Model: Schmidt 1		Date: 15-Mar-99	No.: 1
Modified Article: FCU		Prepared by: Y. Okunishi	
From: GTSS Field Information Dept			
Reason for Modification:	<input type="checkbox"/> Parts catalog correction <input type="checkbox"/> To facilitate assembly <input type="checkbox"/> Part standardization	<input type="checkbox"/> Vendor change <input checked="" type="checkbox"/> To improve reliability <input type="checkbox"/> Other	<input type="checkbox"/> To meet standards ()

Model: Schmidt 1 (FAX2000L)	Date: 15-Mar-99	No.: 2a
-----------------------------	-----------------	---------

Modified Article: Drive Section (Paper Exit Roller Gear)		Prepared by: Y.Okunishi	
From: GTSS Field Information Dept.			
Reason for Modification:	<input type="checkbox"/> Parts catalog correction <input type="checkbox"/> To facilitate assembly <input type="checkbox"/> Part standardization	<input type="checkbox"/> Vendor change <input checked="" type="checkbox"/> To improve reliability <input type="checkbox"/> Other	<input type="checkbox"/> To meet standards ()
Modification Schedule	March 1999

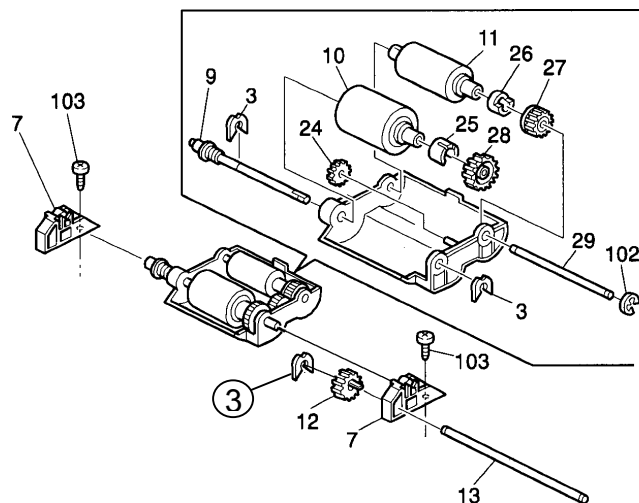
Old part number	New part number	Description	Q'ty	Int	Page	Index	Note
H5351040D	H5351040E	ADF Feeder Unit	1	O/O	9	8	
H5351556	H5351530	Feed Roller Collar	1	O/O	9	25

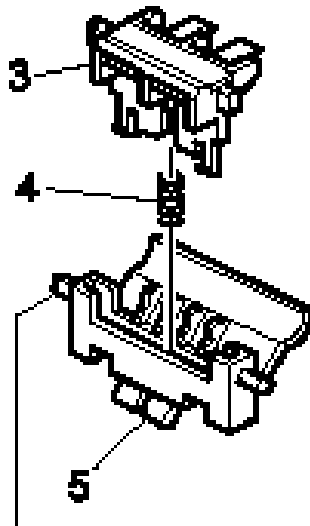
To ensure that paper jams and misfeeds do not occur at the paper entrance area, the Separation Pad has been changed, and a Separation Unit has been newly registered (consisting of the pad, holder, and spring).

Old part number	New part number	Description	Q'ty	Int	Page	Index	Note
H5453155	H5463111	Separation Pad - SS	1-1	O/O	23	3	
	H5463101	Separation Unit - SS			23	23

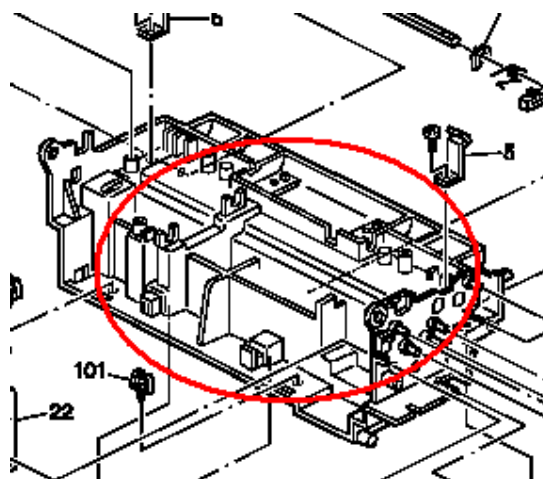
The Scanner Base has been registered as a Service Part.

Old part number	New part number	Description	Q'ty	Int	Page	Index	Note
-	H5451100	Scanner Base	1	-	11	-

Old part number	New part number	Description	Q'ty	Int	Page	Index	Note
-	H5351100	Scanner Base	1	-	11	-
